TECHNICAL BULLETIN

MODEL/DERIVATIVE:
New Discovery
Defender

Bulletin N°: 0010
CDS. ref: L8471bu
Issue: 1
Date: 28.10.98

FUEL COOLER FIXINGS - CHANGE TO TORQUE SPECIFIED

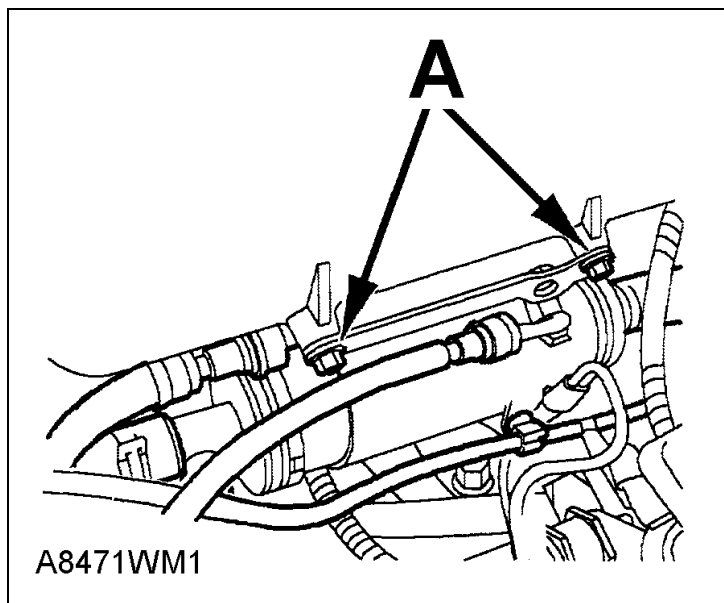
There is a risk of stripping the inlet manifold threads for the upper two fuel cooler mounting screws when tightening to the originally specified torque.

Insufficient screw thread engagement in the inlet manifold to support the tightening torque normally specified for an 8mm screw fixing.

1. Clean the two upper fixing screws, (A in illustration) and the inlet manifold threads, apply Loctite 242 to the screw threads and refit the screws to the inlet manifold.
2. Tighten the screws A to the revised torque of 18Nm.
3. The lower fixing screws torque remains at 25Nm and Loctite is not required.

- Discard the two upper fixing screws, clean the inlet manifold threads and fit new patchlock screws FS108127ML.
- Continue as 2 and 3 above.
